DESIGN/PROCESS CHANGE NOTIFICATION

FSPK146NY is currently assembled at AIC Semiconductor Sdn Bhd, Malaysia using below bonding layout and with gel coating on IC die. The Bill of Materials (BOM) is listed in the following table.

FSPK146NY		
-----------	--	--

New bonding layout for AIC and Vigilant are shown below.

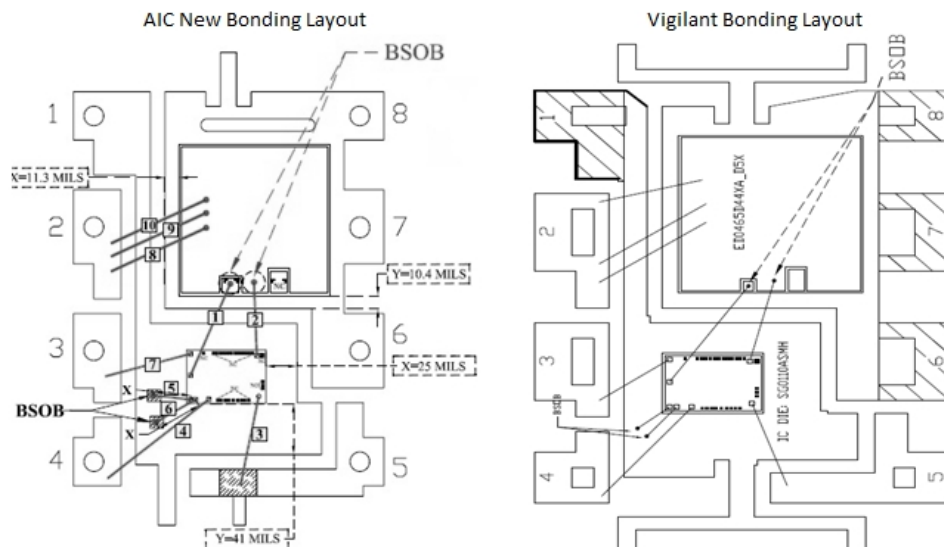
Improve the bonding layout by rotating the IC die to zero degree angle to shorten the wire length and remove the gel coating on IC die.

Bonding layout is improved by rotating the IC die to zero degree angle to shorten the length of wire that is crossing-over the die surface. Shortening the wire length reduces risk of damage due to wire sweeping and mis-handling. Gel coating on IC die was removed to simplify assembly process, reduce delamination, and improve ground bond integrity. Removal of gel coating has been verified to have no significant impact on device's electrical characteristics, yield, as well as reliability performance.
